ADDENDUM NUMBER 2
TO THE DRAWINGS AND SPECIFICATIONS

PROJECT: Washington Street Gym HVAC Improvements

FOR: Macomb CUSD No. 185
323 W. Washington Street
Macomb, IL 61455

A/E PROJECT NO: 2547 0220

SHEET
M501

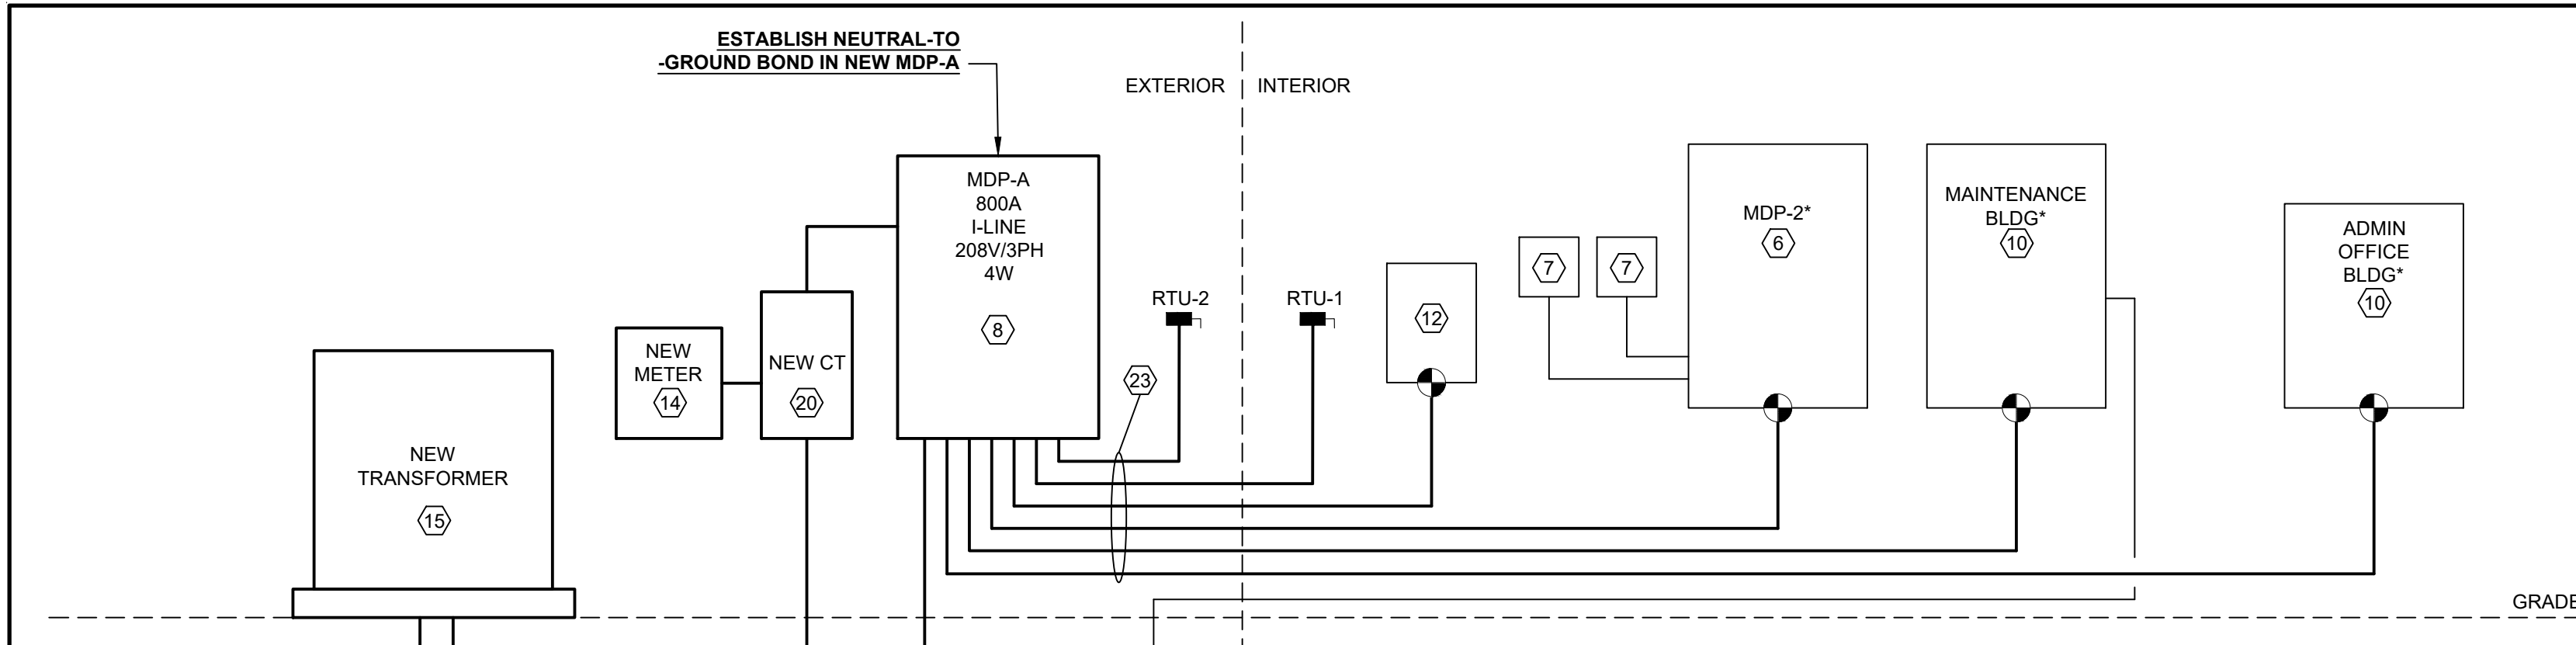
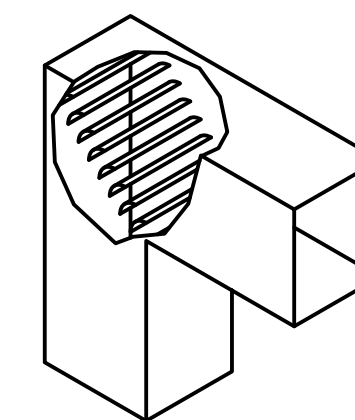
5. TO THE DRAWINGS AND SPECIFICATIONS; Any conduit and gas pipe exposed to view mounted on the building wall shall be painted to match the building. Prime and DTM as appropriate for the pipe material.
6. TO THE DRAWINGS; M501 and E101: Revise electrical, RTU-1 and RTU-2.
 - a. Revise to 1 ¼" conduit.
 - b. RTU-1: #2 wire size
 - c. RTU-2: #3 wire size
